TECHNICAL SERVICE BULLETIN

4WD - Grinding/Clicking/Ratcheting Noise From Front Wheel Area

24-2188

This bulletin supersedes 22-2219. Reason for update: revised Part List and Service Procedure to clarify applicable steps by vehicle application

Figure 1 - Electronic Shift-On-The-Fly (ESOF)

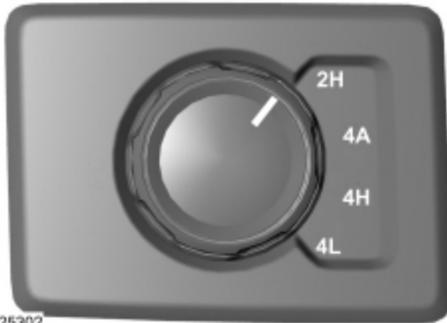
- (1). For vehicles equipped with a MSS that only includes 2H, 4H and 4L positions (Figure 1), proceed to the Electronic Shift On-The-Fly (ESOF) Transfer Case procedure.
- (2). For vehicles equipped with a MSS that includes a 4-wheel auto (4A) option (Figure 2), proceed to the Torque-On-Demand Transfer Case procedure.

1. Is the vehicle a 2017-2018 F-150?

- (1). Yes - reprogram the TCCM using the latest version of the IDS scan tool while connected to the internet. Proceed to Step 2.

- (2). No - for all vehicles, refer to the 2018 F-150 WSM, Section 308-07A Four-Wheel Drive Systems, Diagnosis and Testing, Four-Wheel Drive Systems - Vehicles With: Electronic Shift Transfer Case, Pinpoint Test N for normal diagnostics. Repair is complete.
2. Perform the vacuum system check procedure. For all vehicles, refer to the 2018 F-150 WSM, Section 308-07A Four-Wheel Drive Systems, Diagnosis and Testing, Four-Wheel Drive Systems - Vehicles With: Electronic Shift Transfer Case, Pinpoint Test N. Repair is complete.

Figure 3

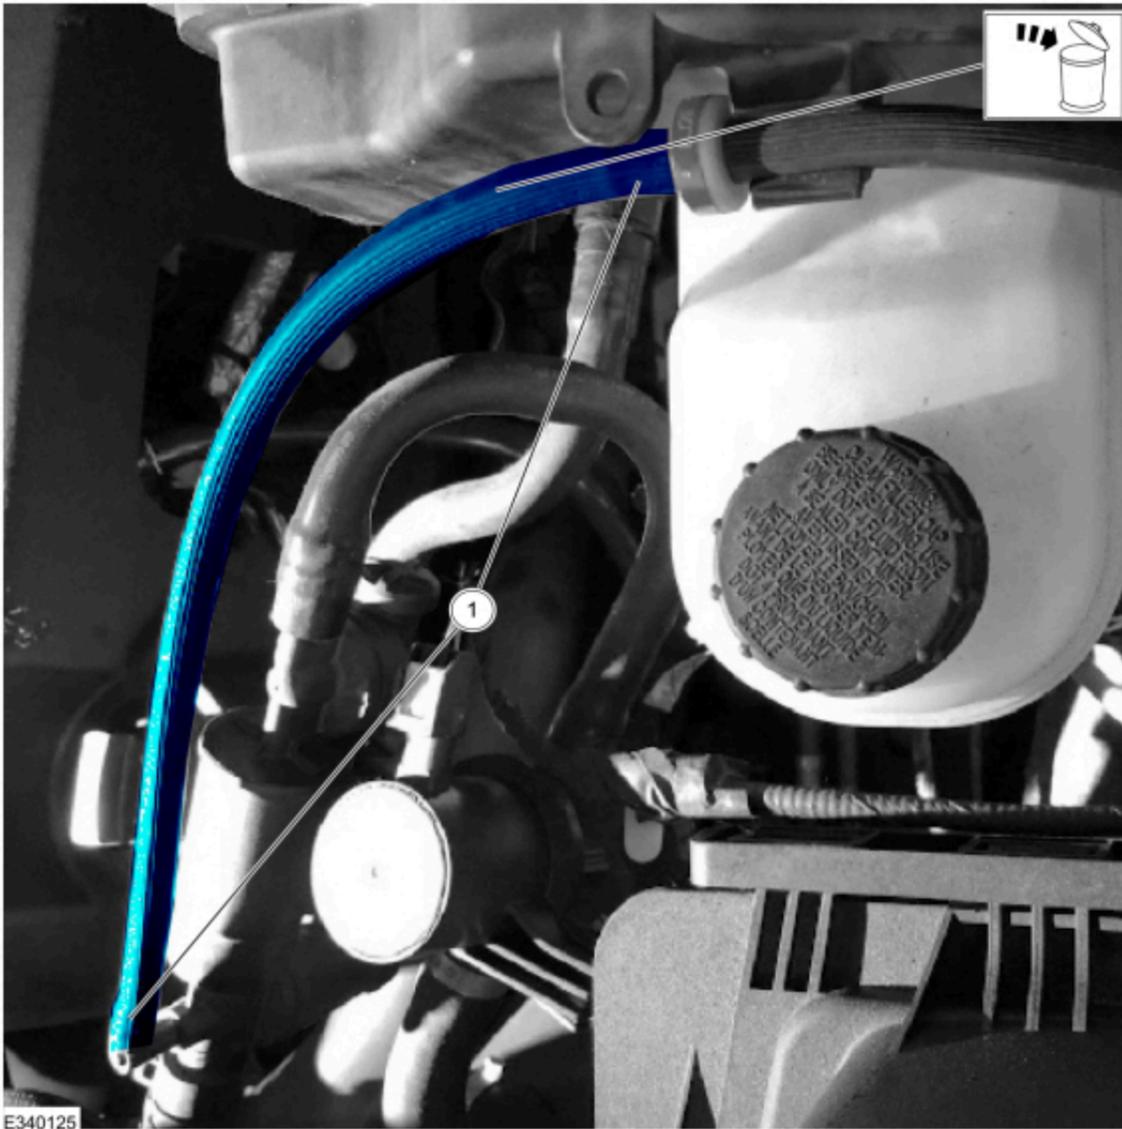
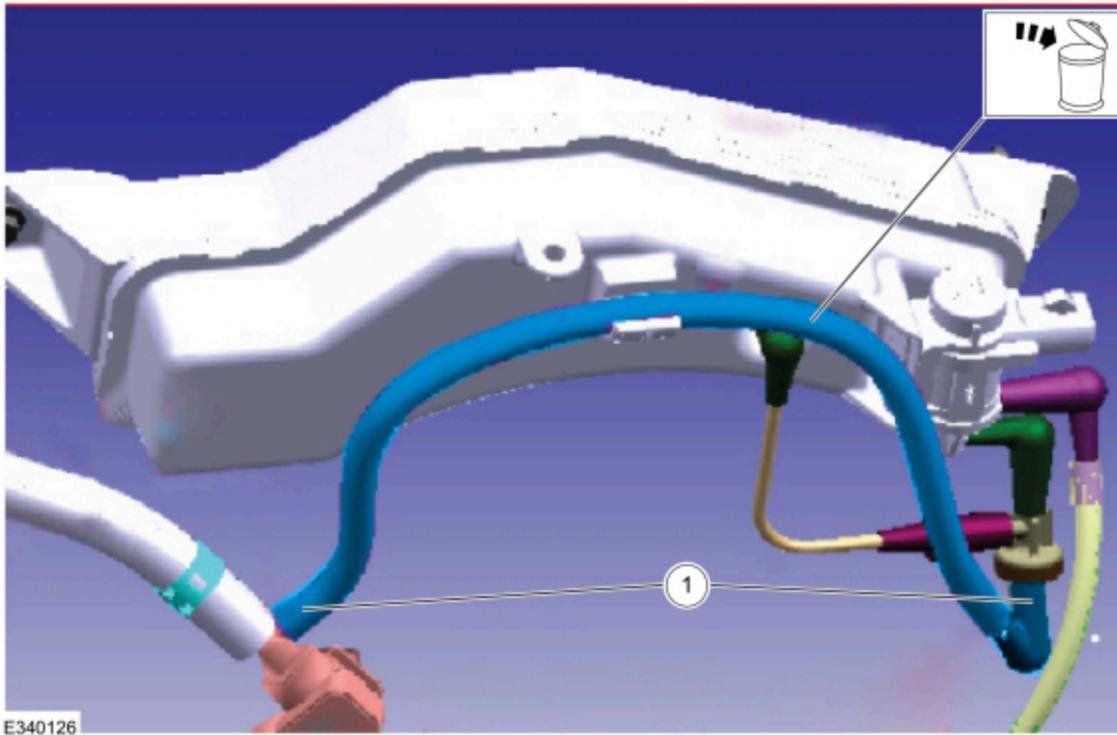
1. Locate the vacuum supply line between the source vacuum and the IWE check valve. Refer to WSM, Section 308-07A. (Figures 3-4)

2. Remove the vacuum supply line.
3. Install the vacuum caps at the IWE check valve and the vacuum source.
